# SERVICE INSTRUCTIONS

**KEATING**  
OF CHICAGO, INC.®

## INSTRUCTIONS FOR REPLACING SPARK IGNITION MODULE (Part # 033762) WITH 24V (Part # 058439)

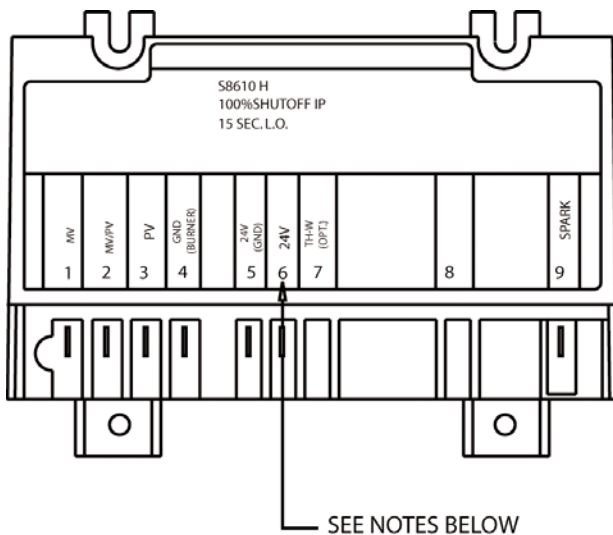
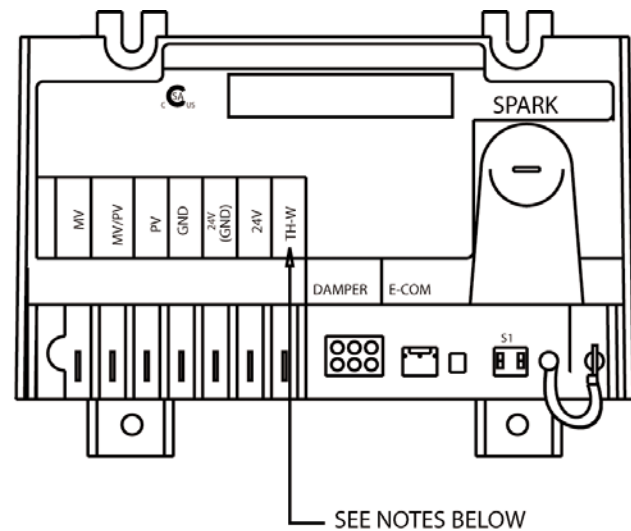
Remove old spark module and mount new module in same location using existing hardware.

Place all wires in the same location on the new module except number 6 24V. Place this wire on TH-W on new module.

NOTE: If the spark terminal on the old module has a boot connection, place the adapter terminal supplied in the box on the cable and connect to the spark location on the new module.
